UNITED STATES PATENT AND TRADEMARK OFFICE

APPLICATION NO.	FILING DATE	FIRST NAMED INVENTOR	ATTORNEY DOCKET NO.	CONFIRMATION NO.
10/625,975	07/24/2003	John E. Hakala	1072-106.US	1695
7590	06/13/2006		EXAMINER	
Colin P. Abrahams Suite 400 5850 Canoga Avenue Woodland Hills, CA 91367			KIM, CHRISTOPHER S	
			ART UNIT	PAPER NUMBER
			3752

Office Action Summary	Application No.	Applicant(s)
	10/625,975	HAKALA, JOHN E.
	Examiner Christopher S. Kim	Art Unit 3752

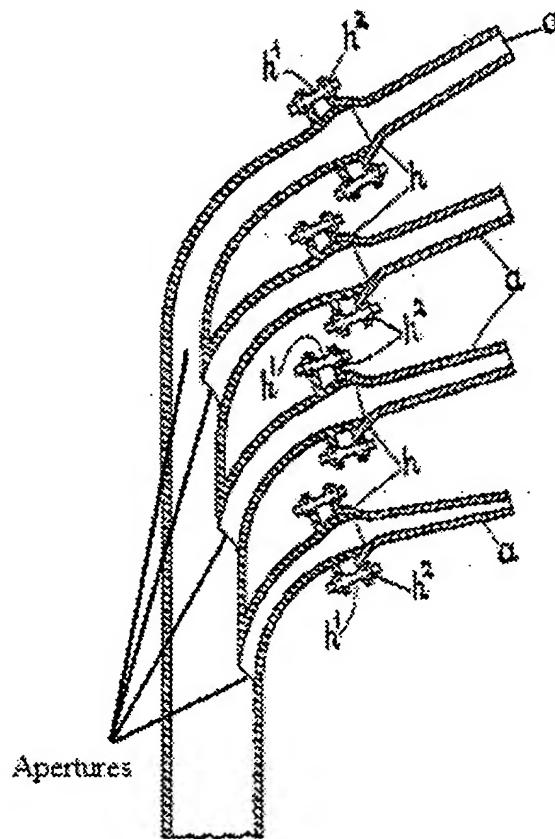
5. Claims 23-28 are rejected under 35 U.S.C. 102(b) as being anticipated by Pougnet (1,102,354).

Pougnet discloses a nozzle comprising: a wall **b** defining a water channel; a water deflector **a**; a further deflector (vanes of pipe **b**) associated with the middle aperture and a deflector (vanes of pipe **b**) associated with the lower aperture. See figure below.

Applicant argues that Pougnet does not discharge water from the apertures in the wall but rather from nozzles in the form of extension pipes projecting outwardly from the all of the vertical pipe b. Applicant's argument is not commensurate in scope with the claimed invention. Claim 23 does not preclude the nozzles a of Pougnet.
